# COCA-COLA REFRESHMENTS EQUIPMENT BULLETIN GENERAL

**NUMBER:** GEN-140

**SUBJECT:** ABS Cup Grabber Block Improvements

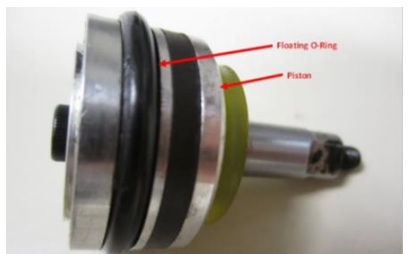
Three failure modes were found and design improvements were implemented against each.

CURRENT		
 Mild Steel Pins	 Cylinder Block O-Ring End Cap	 Faulty Seal Piston
NEW		
 Stainless Steel Pins	 024 O-ring Gland	 Floating O-Ring Piston
Mild steel pins ➔ Stainless steel pins	Spiral clip-contained o-ring ➔ Groove-contained o-ring	Conventional seal ➔ Floating seal
Eliminates corrosion-related jamming of arms	Eliminates leaking end caps	Reduces incidence of leaking across the piston

In addition to design changes at the manufacturer for new parts, field-returned parts are to be remanufactured to include all design improvements.
